## **Citroen C5 estate** **Model year up to 18 February 2002**

### **Engine will not start**

**Bulletin**

Fig. 1

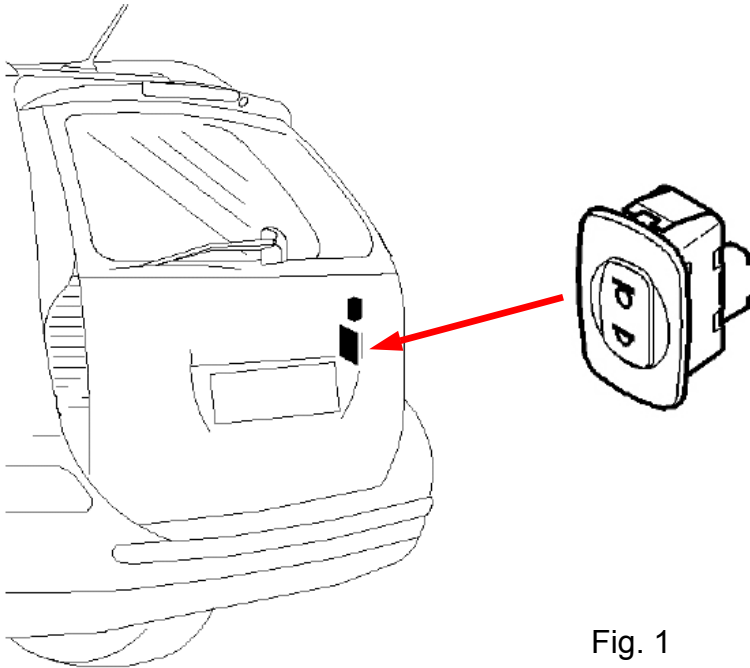
- Remove the switch for the suspension height (on the right, in the boot, see Fig. 1). When removing the switch, care and patience are required due to the fastening.
- Remove the plug from the switch.
- Press down the locking tab of the earth cable 7749 (see Fig. 2) and pull the socket contact out of the plug housing.
- Cut off and insulate the earth cable where the wiring harness exits.
- Refit all removed parts in reverse order.
